Date: April 23, 2008
 To: T10 Technical Committee
 From: Alvin Cox (alvin.cox@seagate.com)
 Subject: SAS-2 letter ballot comment updates for transmitter and receiver tables

Abstract: The attached information is a result of discussions concerning letter ballot comments on SAS-2 related to the 6Gbps transmitter device, reference transmitter, and physical receiver testing.

Figure xxx – Delivered eye opening

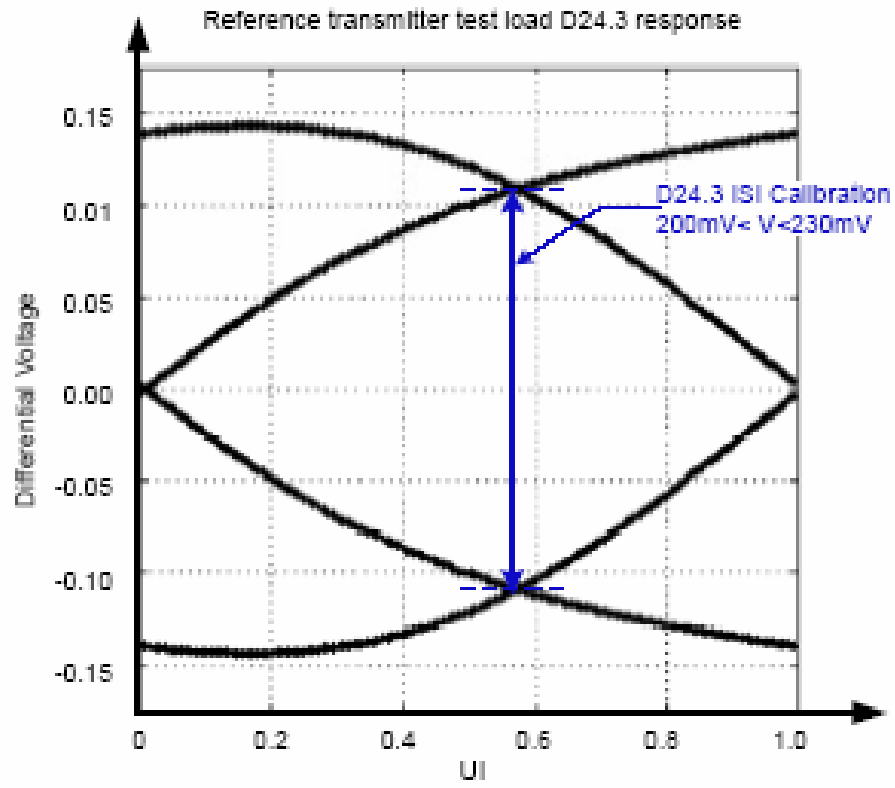
- a Link dispersion penalty is the WDP of the delivered signal computed with Palloc = 15.4 dB.
 b This ~~specification value~~ pertains to the delivered signal at IR or CR during the receiver device compliance test. All adjacent phys in the receiver device shall be active with representative traffic with their maximum amplitude and maximum frequency of operation. Additional pseudo-random crosstalk shall be added, if needed, to meet the total crosstalk amplitude specification.
 c Observed with a histogram of at least 1 000 ~~hits~~ samples.
 d Bounded uncorrelated jitter (BUJ) is the part of the deterministic jitter not aligned in time with the data signal being measured. Specifically, this excludes ISI and DCD. See MJSQ.
 e An SSC modulated source may be used instead of fixed offset frequency crosstalk.
 f Based on the centroid of the vertical histogram at 1 and 0 crossing (see Figure xxx)
 g Nominal values represent target settings for configuration of the test setup. If minimum and maximum values are also included, the test setup value shall be within this range (i.e., a range is required when using physical implementation), however, these ranges shall not be used as corner test conditions required for specification compliance.
